Trinity Grammar School Stage 1 works

SSD 10371 – IPC Questions

Advice in Reply

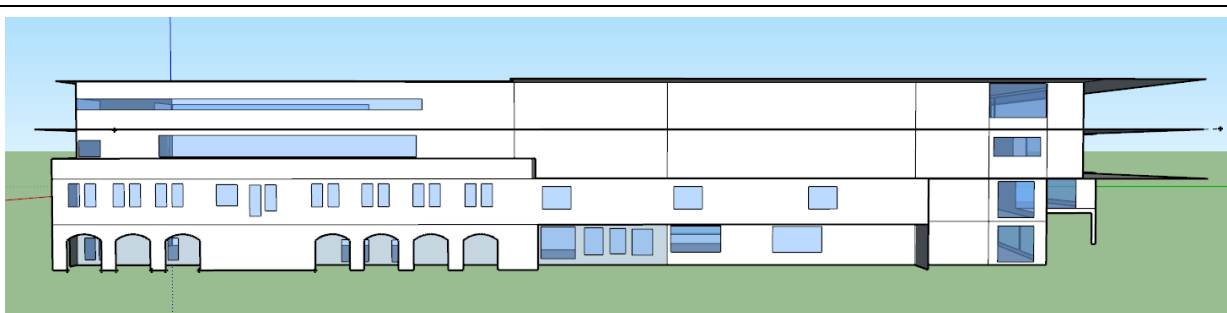
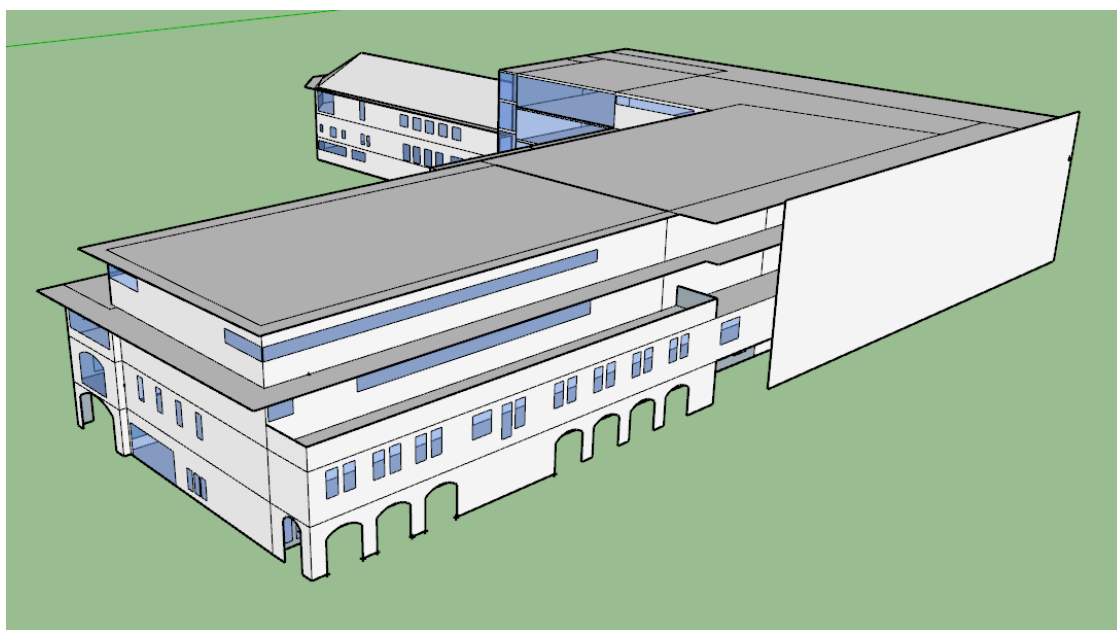
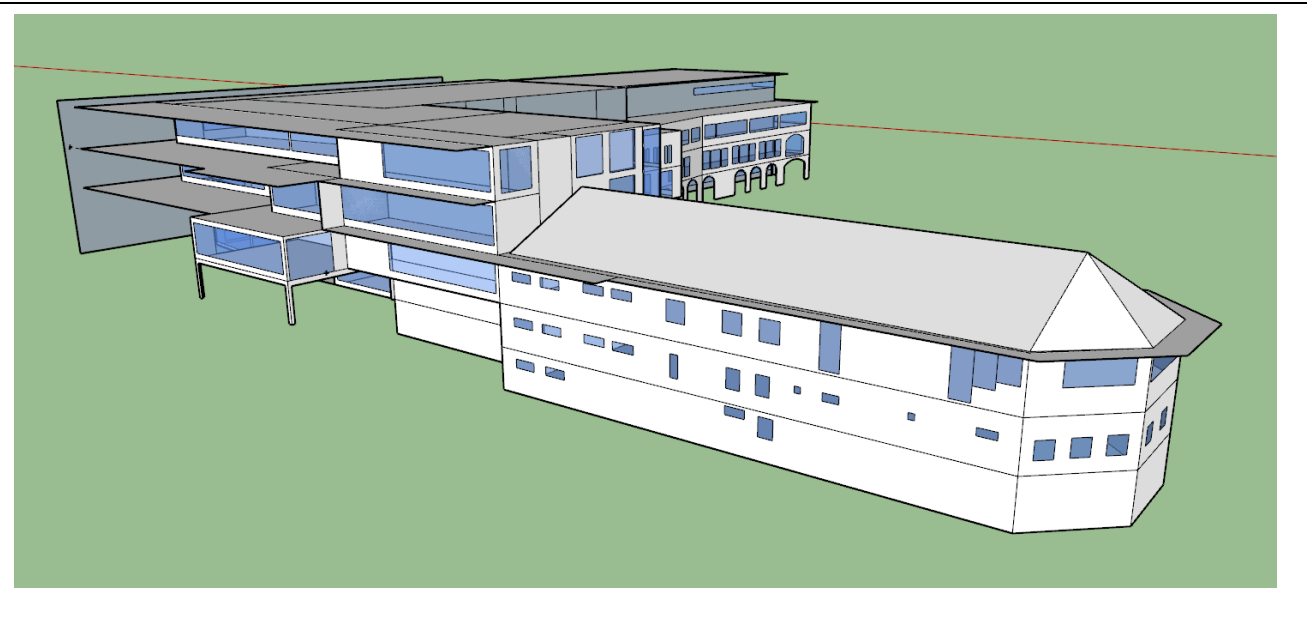
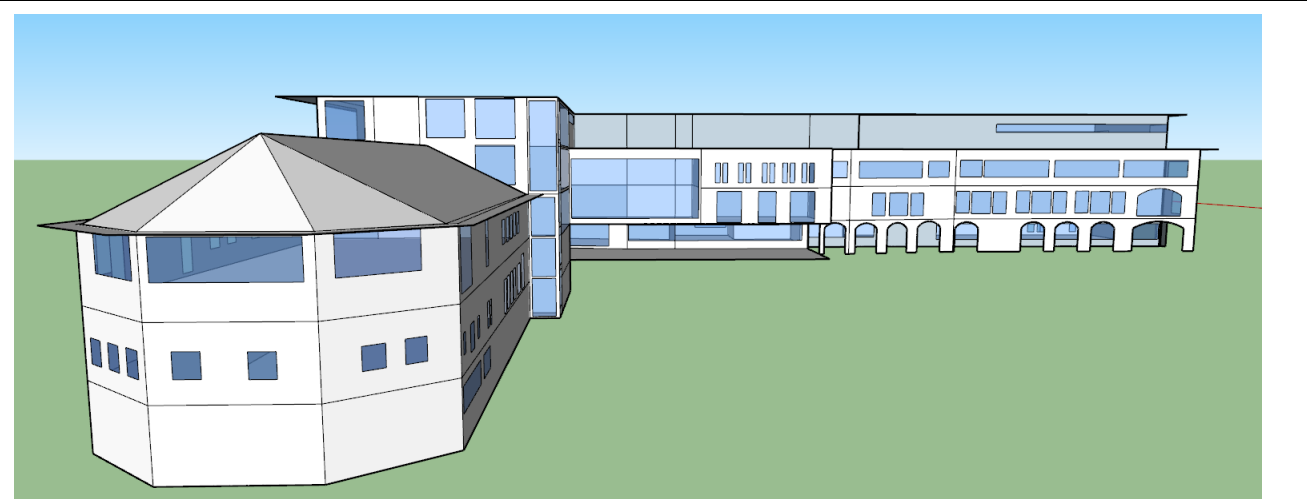
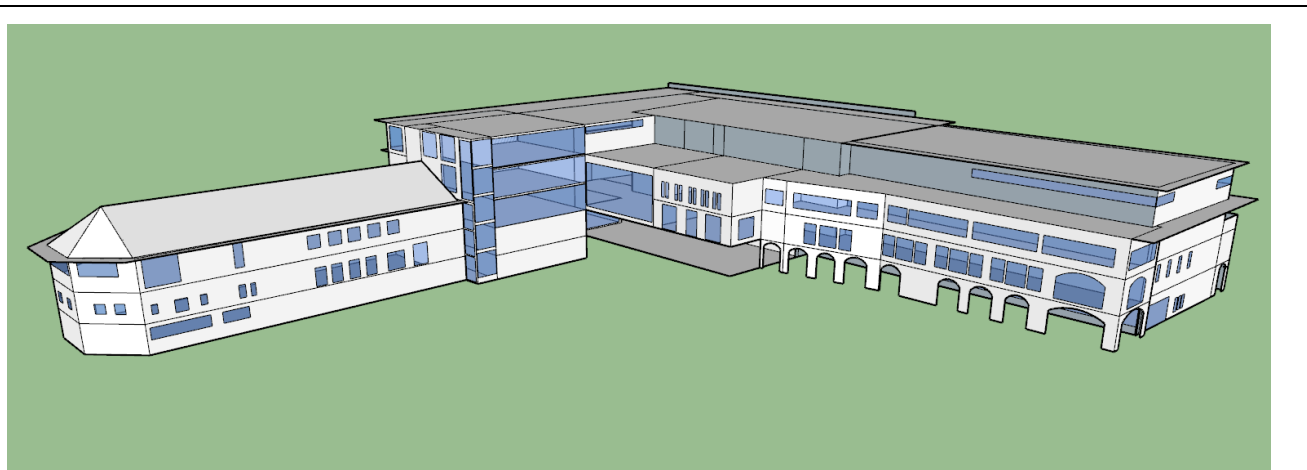
Q: 18.6. “The development has addressed these items as detailed in the points 3.1 to 3.18 by the use of:

- Maximising natural cross ventilation.
- Drought tolerant landscaping by indigenous species.
- Stormwater and rainwater capture for irrigation reuse.
- Shading and thermal massing.”

Question: Has the Applicant carried out modelling and analysis of the strategic planning and detailed Architectural proposal? If so, could the Applicant please provide a copy of the analysis to the Commission?

A: The Applicant engaged ACOR to undertake a detailed analysis of the proposed Architectural façade treatments **prior to** the submission of the Application. This strategy was aimed at establishing a higher level of confidence that the proposed elevations could reliably be engineered to comply with NCC/BCA requirements.

ACOR used the ABCB “Façade (beta) 2019” calculator, Version 0.9 to assess Deemed to Satisfy requirements for the proposed development.

ACOR also used IES Virtual Environment software to assess the proposed development and evaluate the various façade options available. Extracts from this process are shown below for your reference.
